## Smith Drive/Louisville Drive Traffic Calming

**2021-11-18 Smith & Louisville Dr dwg Markups.pdf**

**SMITH DRIVE/LOUISVILLE DRIVE  
TRAFFIC CALMING**  
 Smith Drive Plan Sheet - Louisville Drive to Dayspring Drive

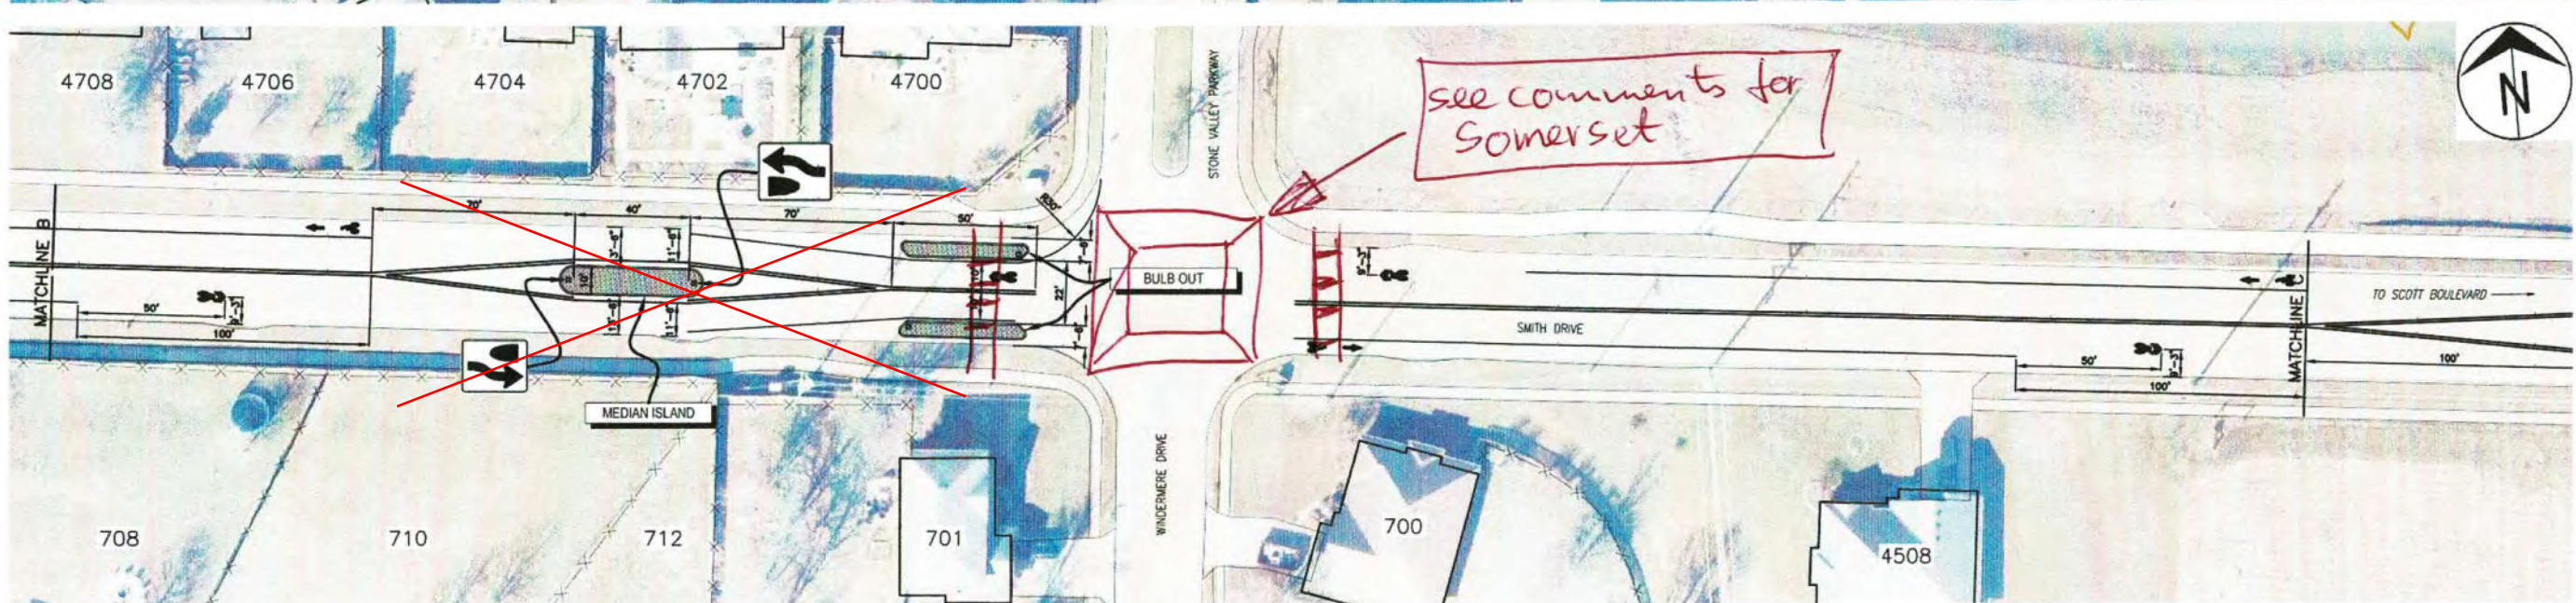
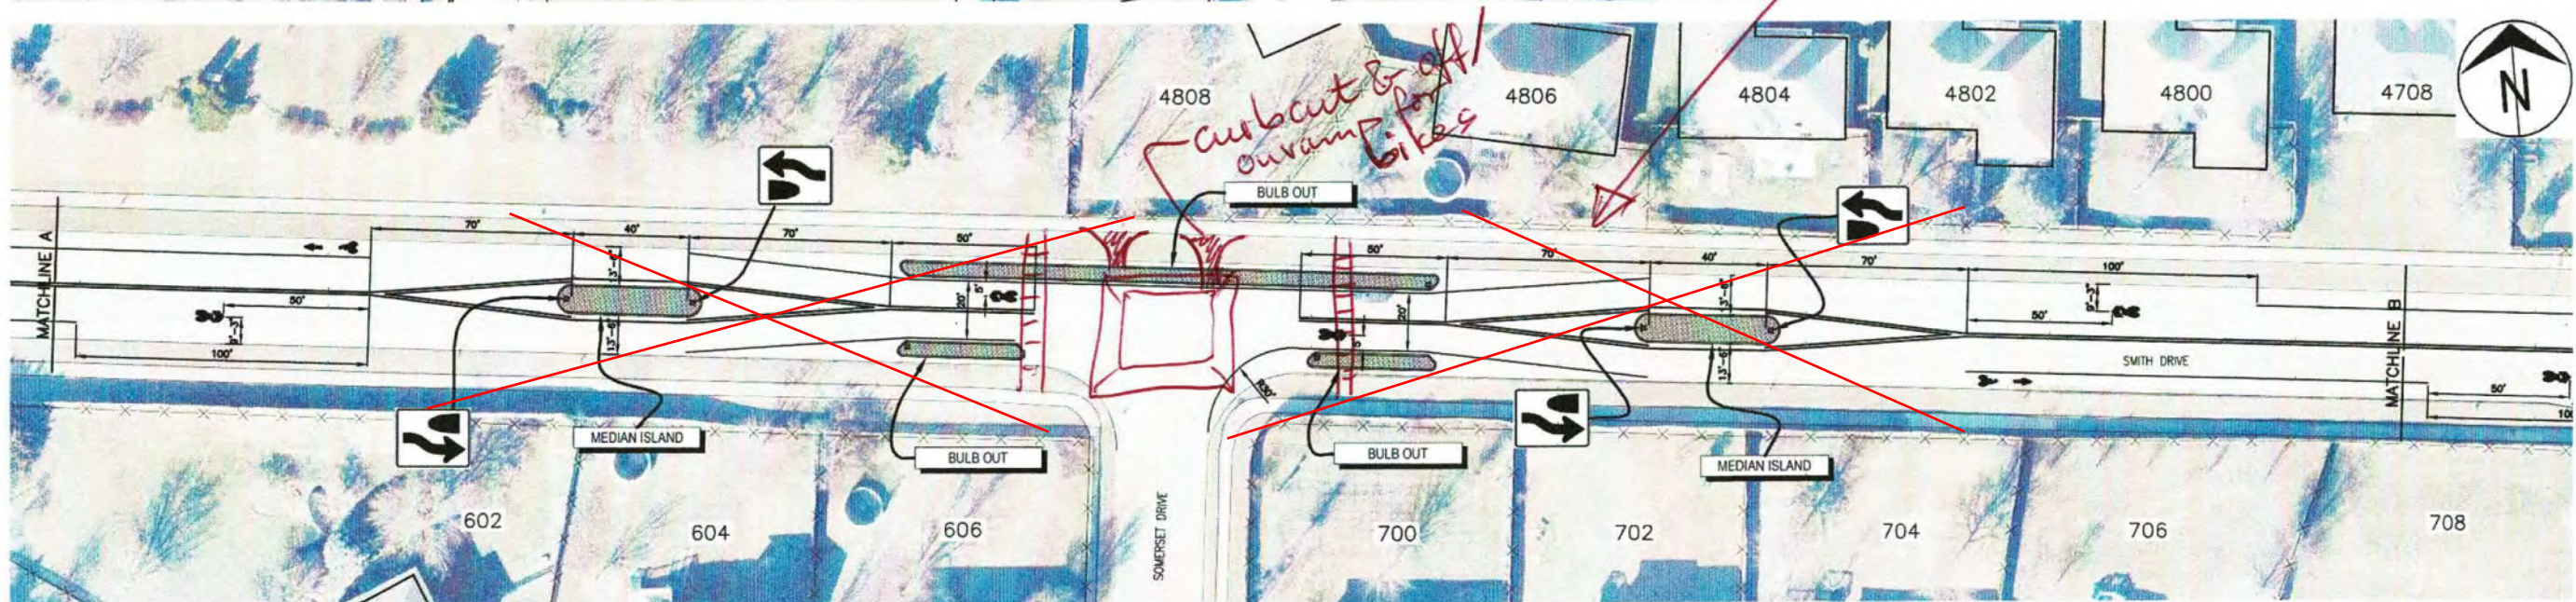
- This design forces bikes into the driving lane. 85% speed is >45mph → unsafe!  
 - Makes snow removal difficult  
 - Low visibility EB due to vertical curve  
 → Add Xwalks on Smith Dr. & Speed Table  
 Current design looks dangerous  
 - Also provide "off" for bikes to/from Somerset to N Smith Dr. SW

Smith Drive Plan Sheet - Dayspring Drive to Scott Boulevard

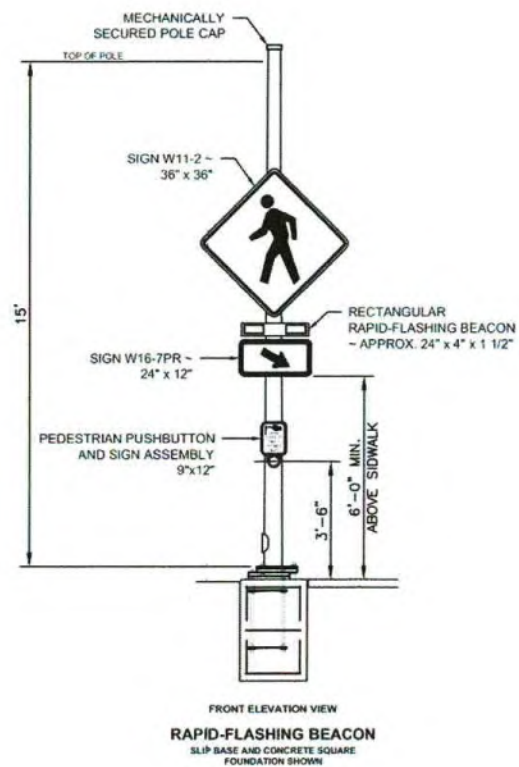
*This is going to develop, provide X walk now*

*consider straightening SW at dead tree stump*

*Narrow driving lanes as needed to stripe Bike paths to intersection. It is dangerous to merge w/ 45+ mph traffic.*

LOUISVILLE DRIVE — RAINBOW TROUT DRIVE  
1" = 20'

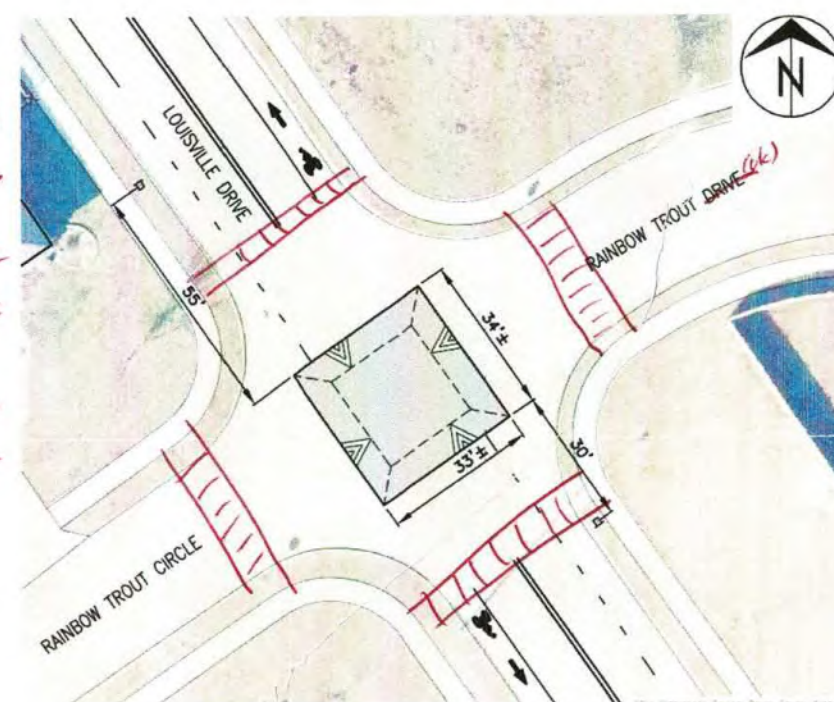
Add 4  
Xwalks  
Both Louisville  
& Rainbow Trout  
Dr. ave  
cut-throughs  
in dense neigh-  
borhood

Add bike on/off ramps to SW. Not needed if Xwalks are constructed.
